**ACRS MEETING WITH  
THE U.S. NUCLEAR  
REGULATORY  
COMMISSION**

**April 7, 2005**

LBLOCA Event Occurring in a PWR

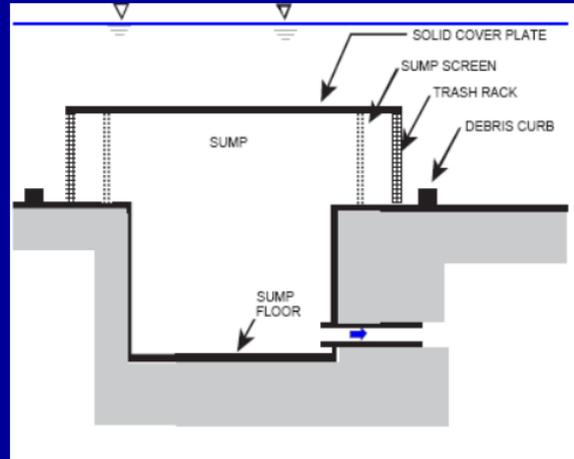
- **RG 1.82, Rev. 3 does not describe methods acceptable to the staff for meeting the requirements**
- **Generic Letter asks for calculations which are dependent on adequate technical guidance**

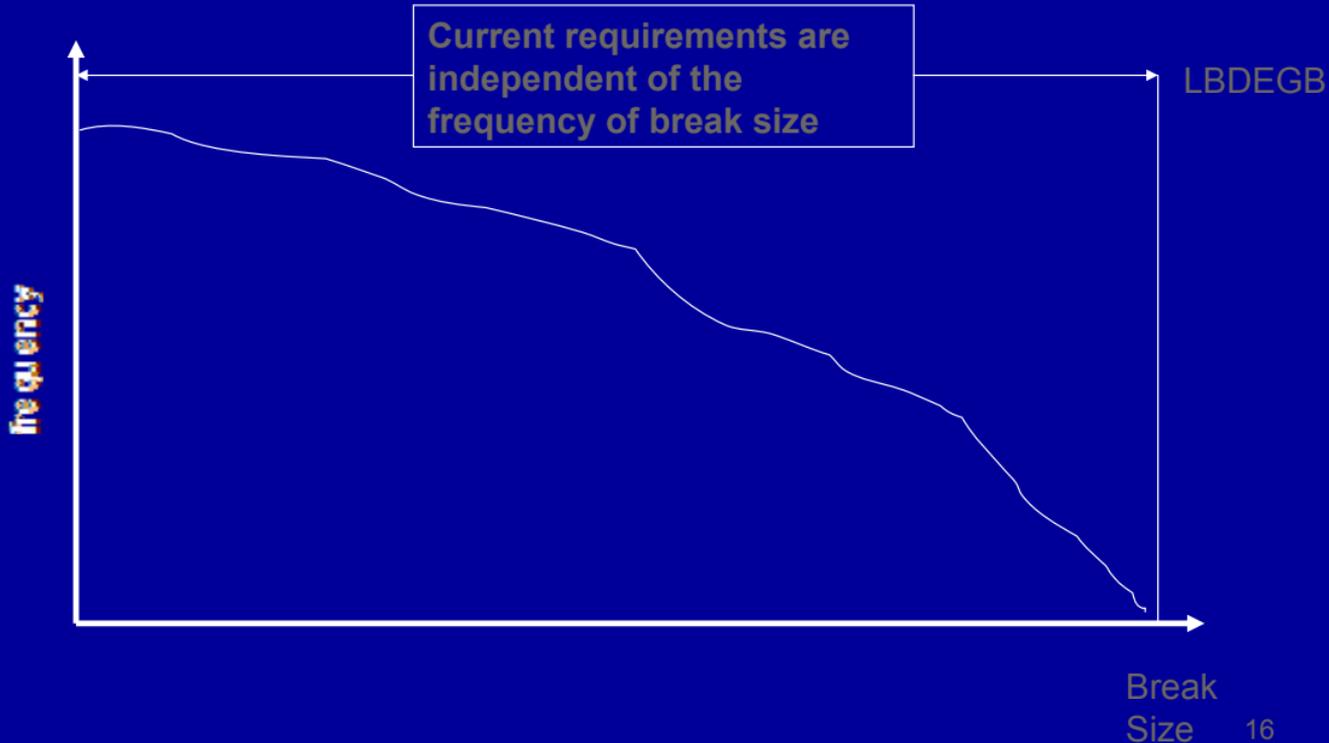
- **Guidance contains errors and inadequacies**
- **Alternative solutions, possibly risk-informed**
- **Need for additional research**

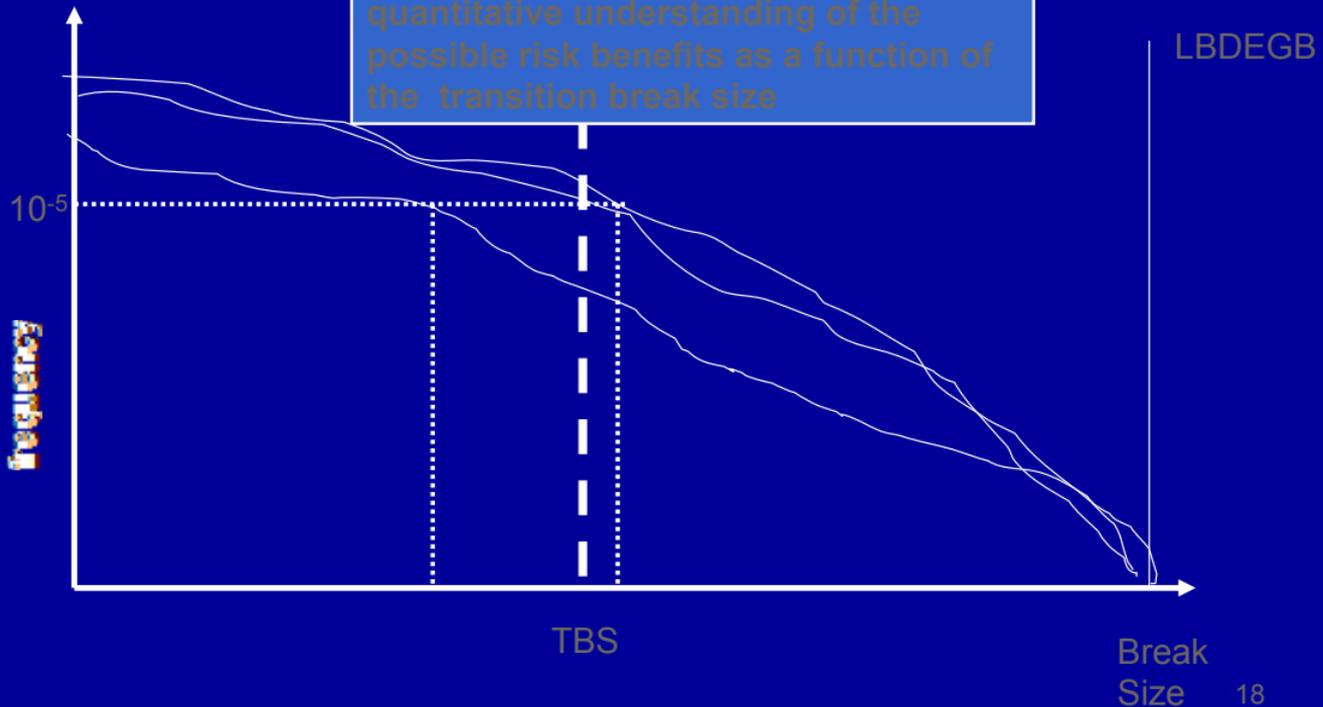
Uncertainties in expert opinions create uncertainty in TBS determination; ACRS supports the development of a quantitative understanding of the possible risk benefits as a function of the transition break size
